SEWAGE DISPOSAL SYSTEM

HOWARD COUNTY HEALTH DEPARTMENT

SUBDIVISION Kindler Estates LOT 11 ROAD 10548 Gorman Road

REPAIR - PURPOSE - IN SUPPORT OF BUILDING PERMIT APPLICATION #B00116871 (Increase in the number of bedrooms), 1 Story Addition with finished basement - 3 bedrooms.

06-491413

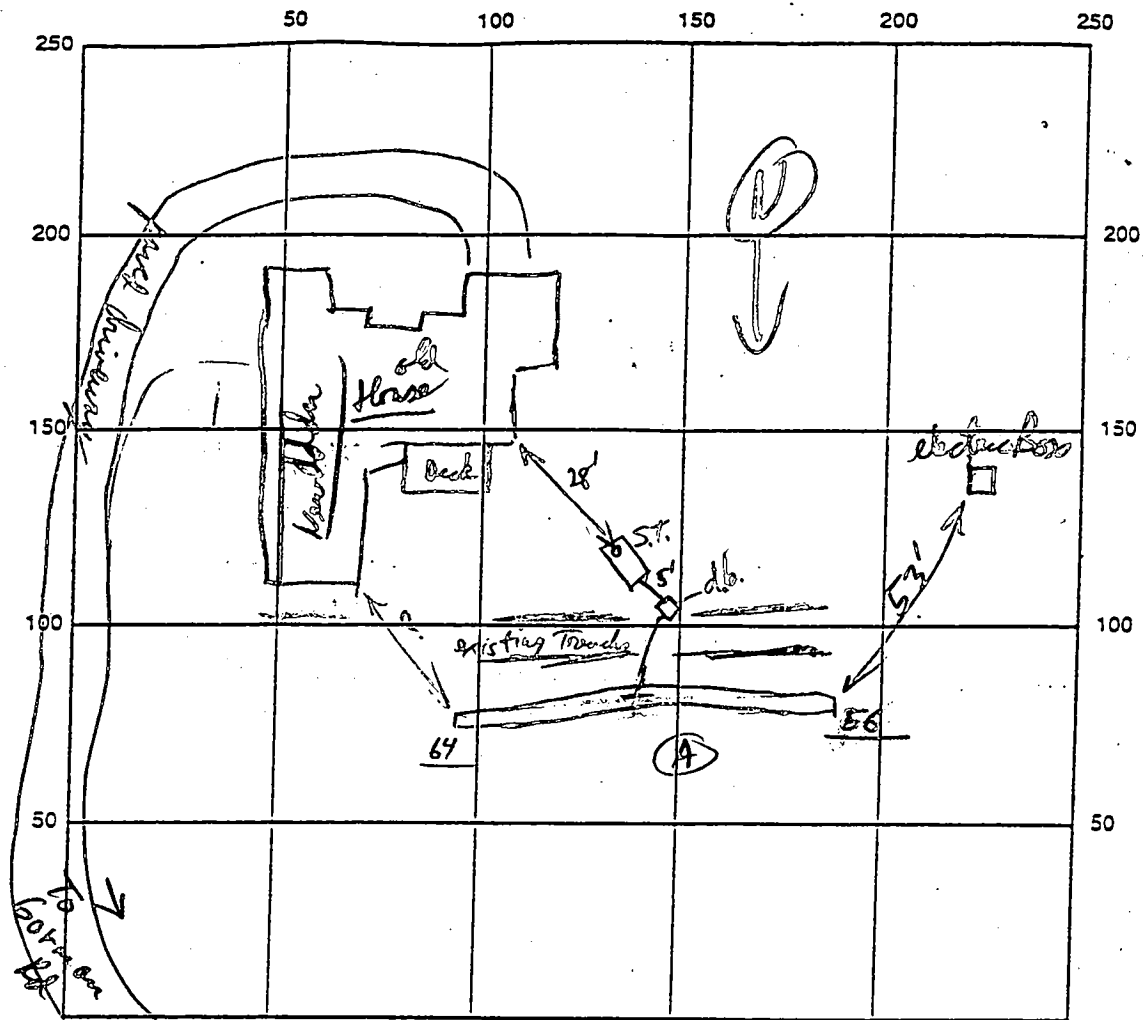
UNABLE TO MAKE INSPECTION AT CONTRACTORS REQUESTED TIME,
CONTRACTOR REPORTS WOODED SITE, ONE OUTLET HOLE REMAINS IN DISTRIBUTION BOX,
BEST CHOICE TO ACCOMMODATE EXISTING CONDITION - CENTER FEED A CONTINUOUS 120'

TRENCH DIRECTLY BELOW EXISTING TRENCHES, KEEP IT SHALLOW!
PLANS APPROVED BY Ronald J. Pinkley [Signature] DATE 4-06-99

REMARKS: Trench is into good soils (Min. loam & Sand loam to 12ft deep in H.A. (only not at area 56). Good loam soil starts @ 1 1/2 - 2ft below grade throughout trench. 1st half of trench OK to continue gravel fill, place pipe & cover once prepared. OK to continue with trench layout as discussed & cover if no further inspections by 3:30 this PM. PP 7/21/99

A
SERIAL # A 32996

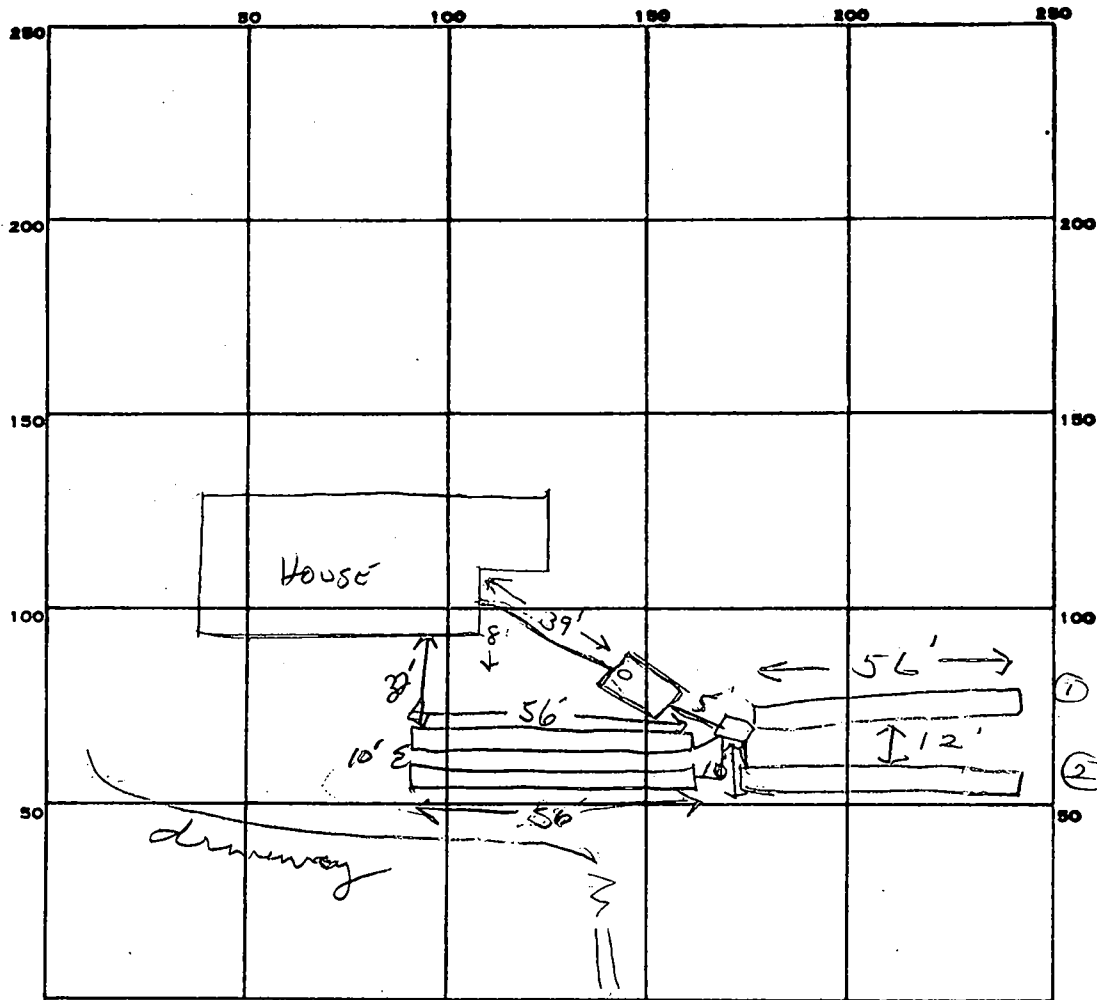
REMARKS 12/11/85 OK to cover two (2) trenches. JS
12/12/85 OK TO COVER

A 32996

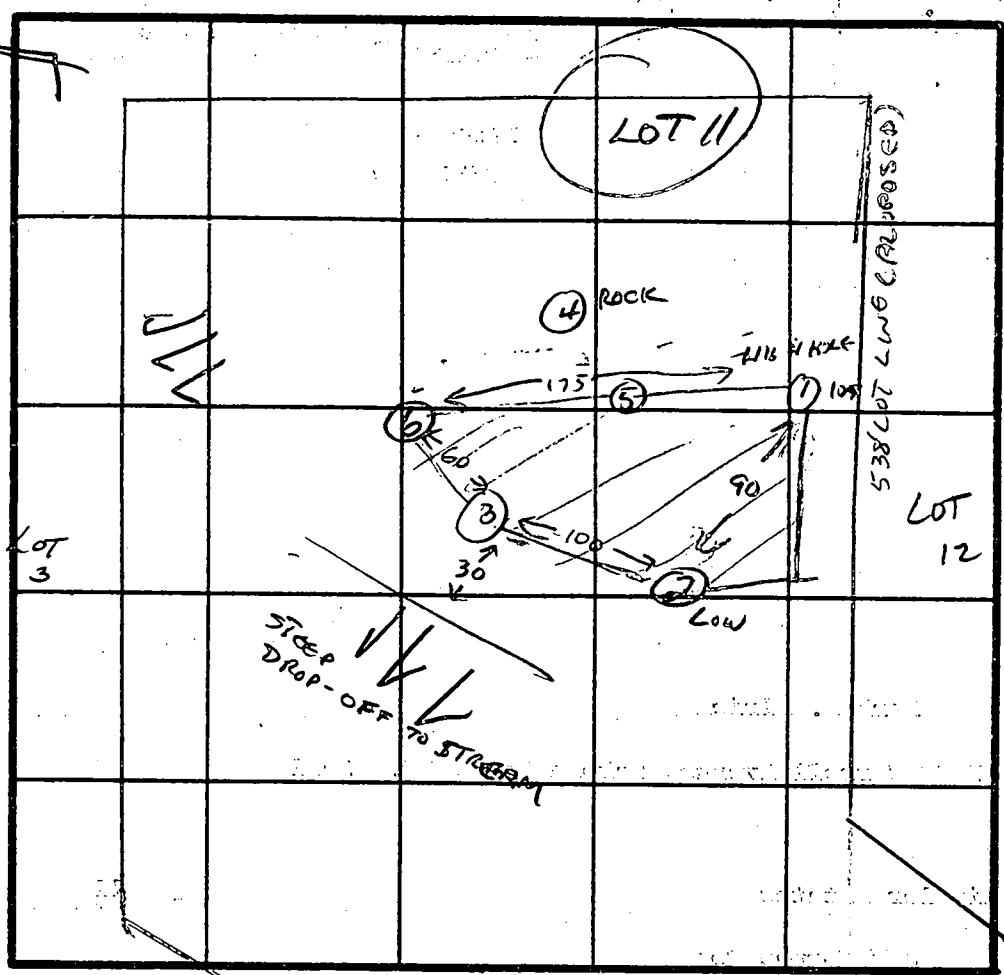
HOLD PENDING FURTHER TESTS C Williams DATE 8-15-83

REASONS FOR REJECTION OR HOLDING NEED CERTIFIED HOLE LOCATIONS

6/19/85 Lot 11 not recorded this is still Lot 4 (public water & public sewer are aduable Contract 548W & 531S y.f.)

REMARKS OK FOR SHALLOW SYSTEM ONLY.

KIMBLE ESTATES
LOTS 11 THRU 14
RESUBD LOTS 4 AND 7 PLAT NO.
6TH ELECTION DISTRICT
HOWARD COUNTY, MD

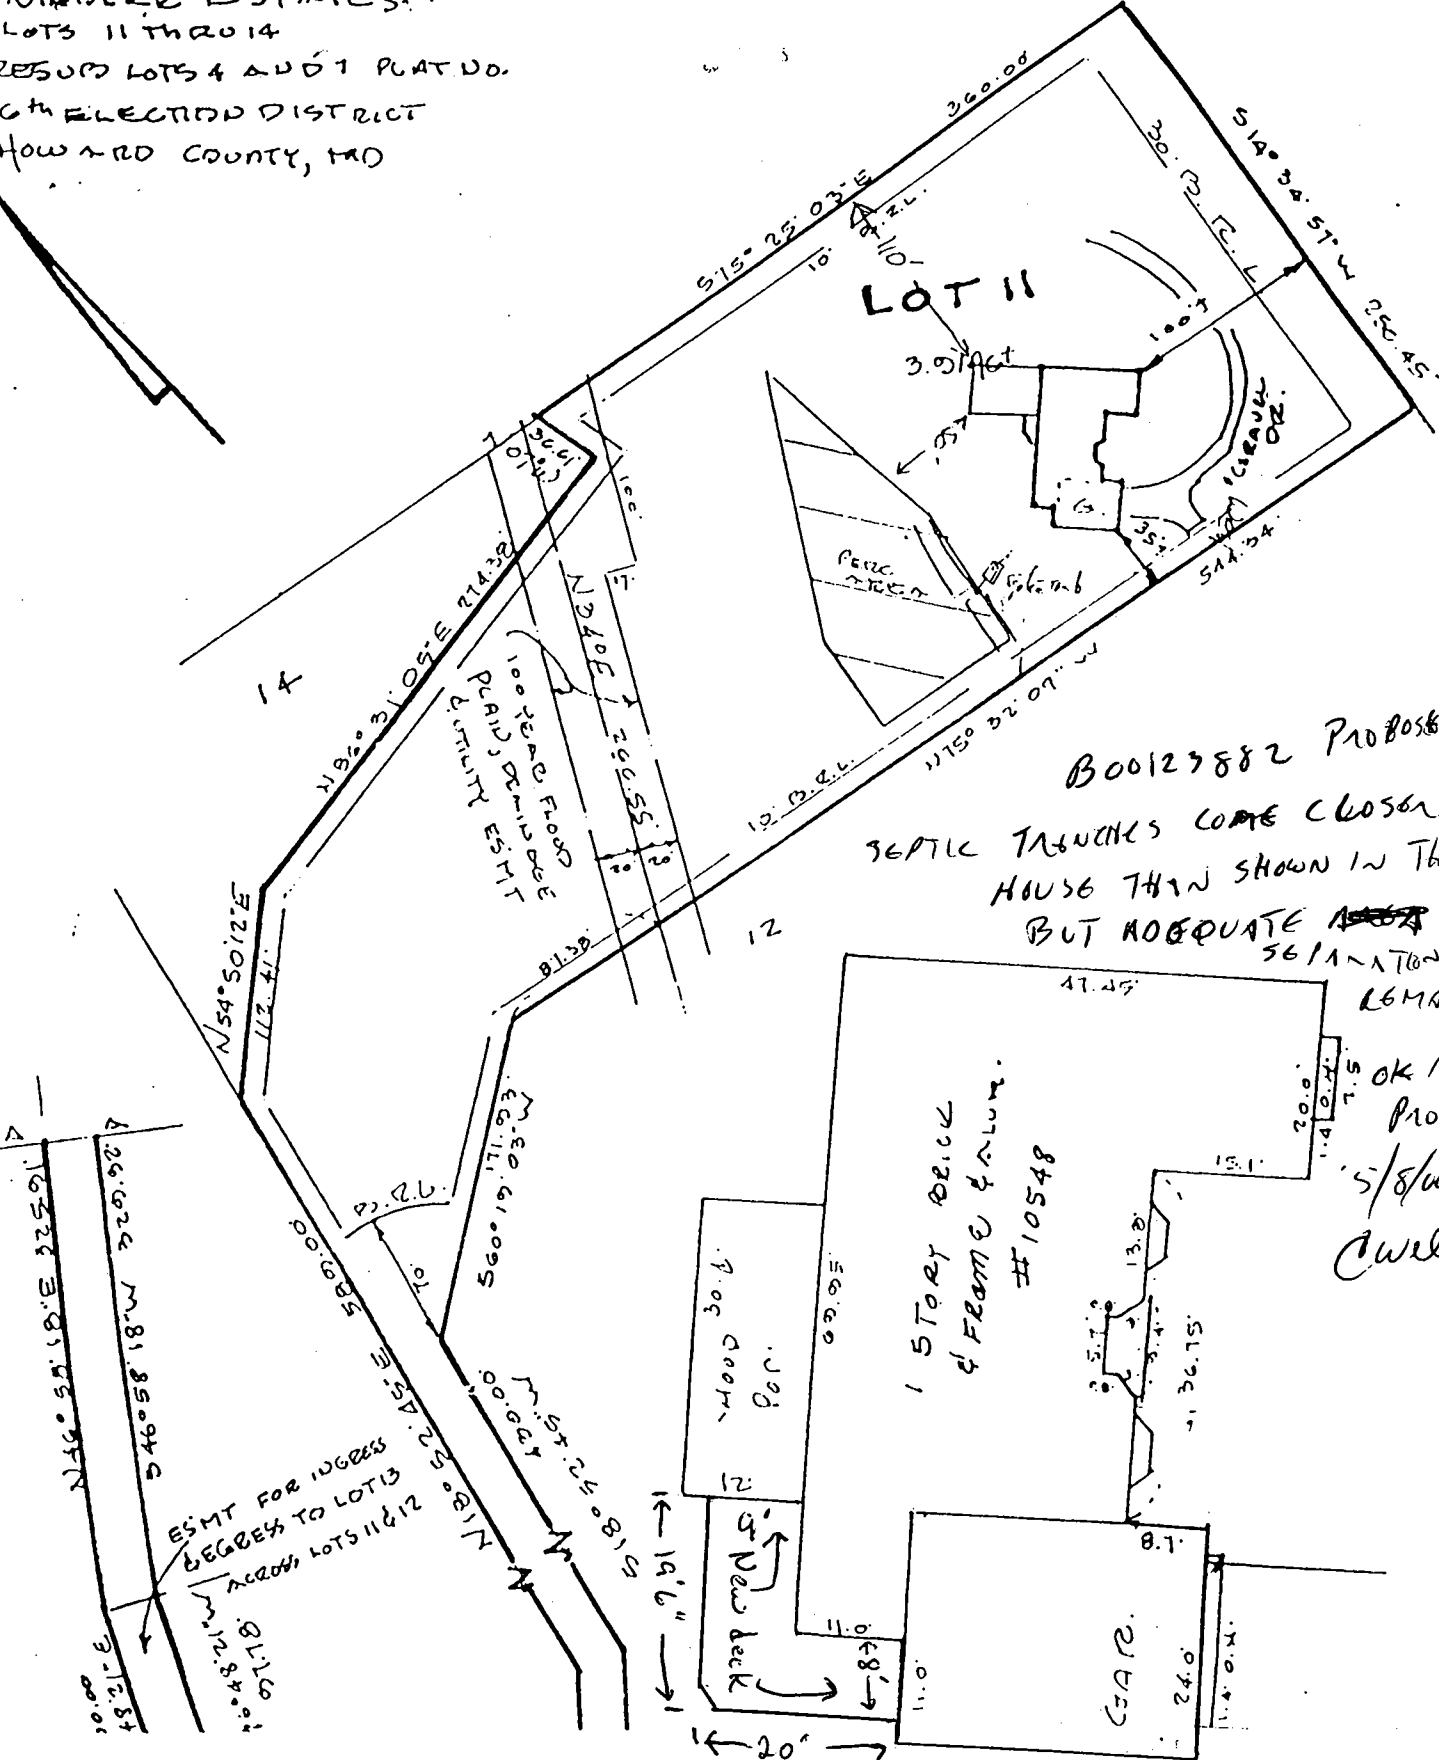
B00129882 Proposed Deck
SEPTIC TANKS COME CLOSER TO HOUSE THAN SHOWN IN THIS PLAN, BUT ADEQUATE SEPARATION STILL REMAINS.

OK AS PROPOSED
5/8/00
Cwell
